**Re: Sioux Lookout Hydro Inc. ("SLHI")  
2013 Electricity Distribution Rates  
Board Staff Interrogatories  
Board File No. EB-2012-0165**

**Sioux Lookout Hydro Inc. ("SLHI")  
2013 Electricity Distribution Rates  
EB-2012-0165  
Board Staff Interrogatories**

Ref: Exhibit 3/Tab 2/Sch. 1

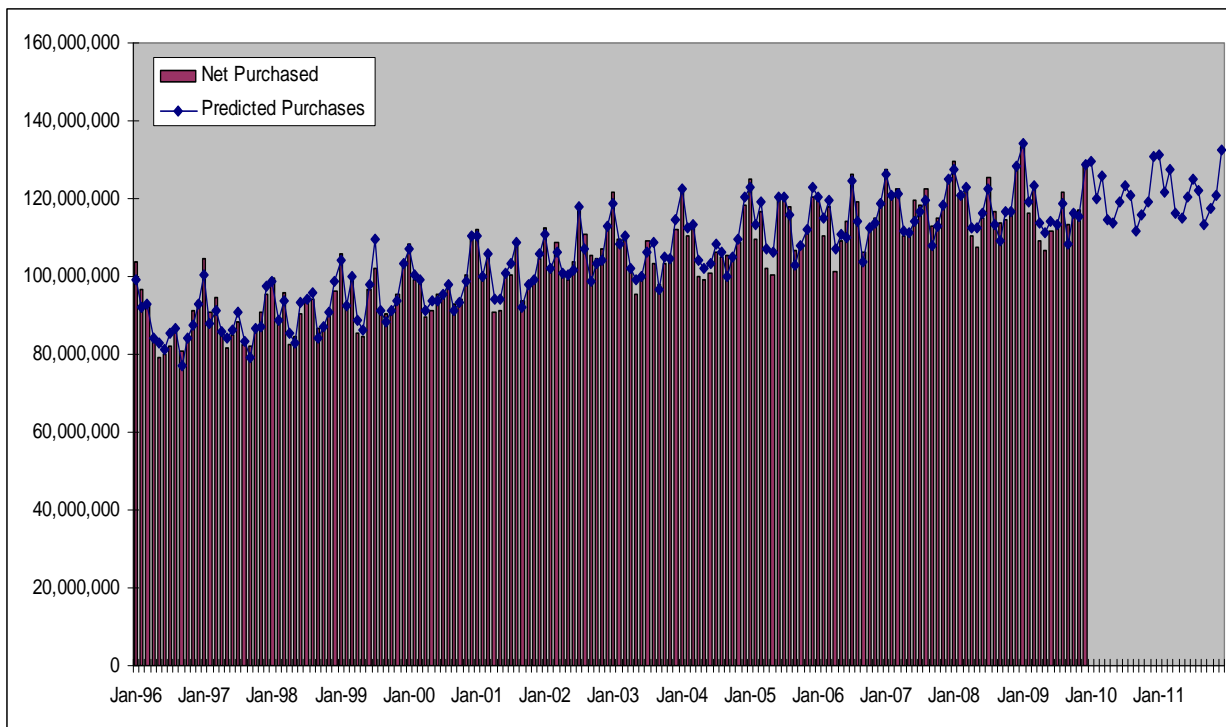
- a) Table 3.5 provides summary statistics for the purchased power regression model. The table shows that the intercept, with an estimated value of 38,179, has a t-statistic of 0, and thus is statistically insignificant. Please explain why the intercept was retained given its statistical insignificance.
- b) Was a variable to account for CDM tried? If so, please provide a general description of the variable and the results, and explain why the variable was not retained. If no CDM variable was tried, please provide an explanation.
- c) Please provide a version of the chart showing the actual and predicted values, comparable to that shown on Exhibit 3/Tab 2/Sch. 1/p. 9, but showing monthly data in a format similar to the following. Include 2012 actuals in the chart if available.

d) Please provide the Mean Absolute Percentage Error from the chart in c) based on the monthly residuals.
